Remarks

Amendments to the Drawings

The attached sheet of drawings includes changes to Fig. 10. This sheet, which includes Figs. 8-10, replaces the original sheet including Figs. 8-10. In Figure 10, previously omitted element 120 has been added.

Fig. 10

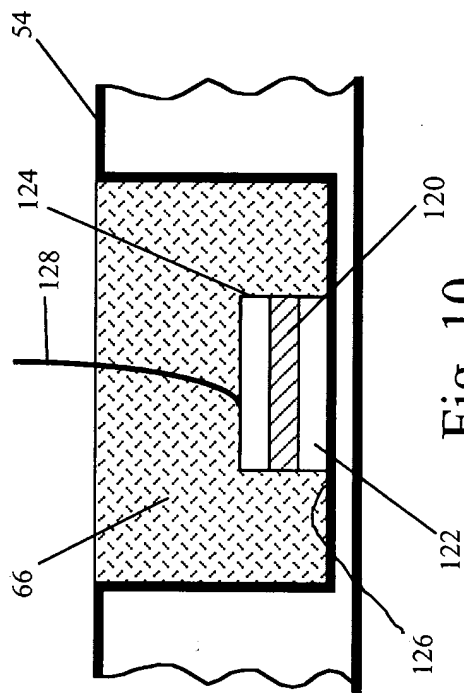
Figure 10 has been amended to show reference numeral 120 and now conforms to the specification at p.8, line 12-13.
